HGY/2017/2220:

Refurbishment and change of use of the Hornsey Town Hall from B1 Use and Sui-Generis Use to a mixed-use scheme comprising a hotel (Use Class C1), food and beverage uses (Use Classes A3 and A4), community uses (Use Class D1, D2 and Sui-Generis Use) and co-working use (Use Class B1).

Partial approval of details pursuant to condition 4 (Hard and Soft Landscaping) excluding Town Hall Square lamp posts lighting columns, attached to planning permission HGY/2017/2220

HGY/2026/0943

Image 7: Plan and Streetview - Proximity of totem lights to The Broadway lighting

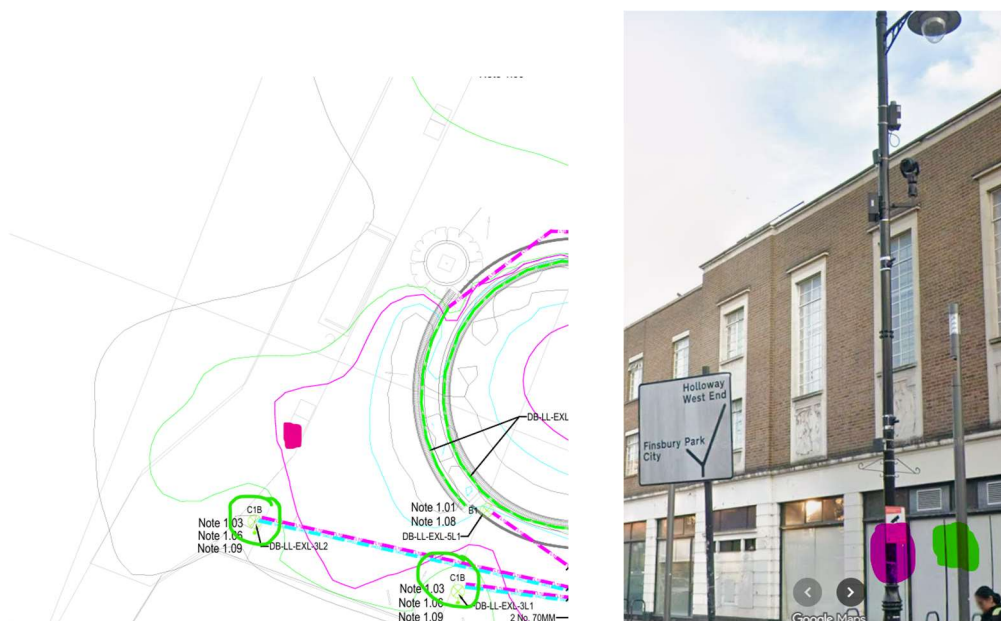
However, the mix of such lighting alongside the additional totem lamp columns in the square results in insensitive and inconsistent designed lighting solutions that are neither consistent with the heritage setting of the Grade II* Town Hall, nor the surrounding Crouch End Conservation Area. The lack of consistency creates a negative impact and stark contrast between these typologies and creates a visually cluttered and undesirable setting for the Town Hall Square. The contrast is all the greater given that efforts have been made to include globe lighting on the frontage of the building itself and the use of historic bollards in the Town Hall Square.

The use of a variety of designs within heritage setting creates a further visual cluttering, especially when viewed in the context of the residential street lighting in Hatherley Gardens and lighting on The Broadway. This is particularly evident in the southwestern corner of the Town Hall Square where the C1B totem light (circled green) is in close proximity to the existing lighting on The Broadway (roughly annotated as a pink dot, although not shown on the applicant's plans). The installed two types of lighting exacerbate the collective appearance of the wider setting as well as lacking heritage led design.

It is considered that the installed lighting in the Town Hall Square is highly incongruous, harmful to the setting of the Grade II* heritage asset and fails to preserve or enhance the character and appearance of the Conservation Area, exacerbated by the variance in design.

Prior to submission, officers had advised that the totem lighting around the Town Hall Square should be replaced with a consistent lighting design in the style of the period globe design installed closer to the Town Hall building. Officers were open to reviewing other period designed alternatives if they better met the needs for lighting and comprehensive lighting strategy for the area, including any potential requirement for supplemental lighting solutions required to support a more sympathetic design, if suitable justification could be provided. However, no such alternatives were presented and so no balance of appearance over function was possible. Limited detail has been submitted to justify any significant public benefits from the installed lighting to justify the harm to the heritage assets of the grade II* listed building nor the character and appearance of the Crouch End Conservation Area.

As such the lighting installation within the site frontage and in the context of other adjacent lighting typologies is considered to be an undesirable and unsatisfactory solution to the detriment of the character and appearance of the grade II* listed building and setting of the Crouch End Conservation Area. On this basis it is recommended that the application be refused and enforced and that the applicant provide alternative design led approach to a consistent lighting solution.
